Access Compliance Report

Public Rights-of-Way

Intersection ID: 28240	Main Street: FORTBRIDGE_LN	Cross Street: SUMMER CLUB_RD	Location: SE
ADA ID: FFB70F42B516	Ramp Type: BlendTrans2	Initial Pass/Fail: Fail	Overall Compliance: No
Severity Score: 12.5			
Codes/Mitigation Info/Possible Solution		Field Measurements/Component Compliance

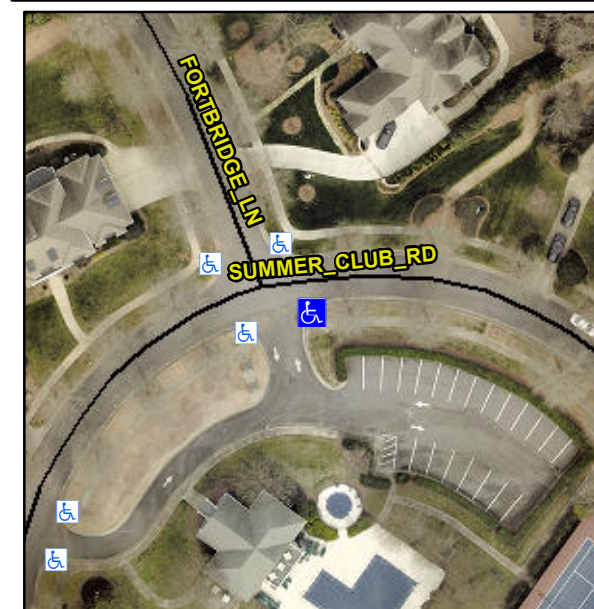
Not Found, R304.5.3

Compliance	Description	Data	Compliance	Description	Data
N/A	Ramp Length (in)	145.5	Yes	BlendTrans Slope (%)	3.0
Yes	Ramp Width (in)	53.0	No	BlendTrans XSlope (%)	5.1
N/A	Flare Type LT	N/A	N/A	Flare Type RT	N/A
N/A	Flare Slope LT (%)	N/A	N/A	Flare Slope RT (%)	N/A
N/A	Flare Traversable LT?	N/A	N/A	Flare Traversable RT?	N/A
N/A	Landing Length (in)	N/A	N/A	DWS Provided?	N/A
N/A	Landing Width (in)	N/A	N/A	DWS Contrast?	N/A
N/A	Landing Slope (%)	N/A	N/A	DWS Length (in)	N/A
N/A	Landing X Slope (%)	N/A	N/A	DWS Full Width?	N/A
N/A	Landing Curb? (Y/N)	N/A	N/A	DWS Offset (in)	N/A
N/A	Shared Landing?	N/A			
N/A	Gutter Ponding?	N/A	N/A	Gutter Slope (%)	N/A
N/A	Gutter Lip Ht (in)	N/A	N/A	Gutter X Slope (%)	N/A
N/A	Painted X Walk1?	No	N/A	Painted X Walk2?	No
	X Walk 1 Direction	To NW		X Walk 2 Direction	To SW
	X Walk 1 Width (in)	N/A		X Walk 2 Width (in)	N/A
	X Walk 1 Slope (%)	1.8		X Walk 2 Slope (%)	2.7
	X Walk 1 X Slope (%)	1.5		X Walk 2 X Slope (%)	1.4

N/A	Ramp inside XWalk1?	N/A	N/A	Ramp inside XWalk2?	N/A
	Road Slope (%)	3.1		Clear Space?	N/A
	Road X Slope (%)	2.6	N/A	Clear Space to XWalk (in)	N/A
N/A	Any Obstructions?	N/A	N/A	Storm Grate/Utility Hazard?	N/A
	Obstruction Type			Storm Grate/Utility Type	
		N/A			N/A
			Yes	Surface Condition? (G/P)	Good
			No	Curb Slope (%)	17.9

Remove & Replace Curb Ramp With Two New Directional Ramps or Equivalent.
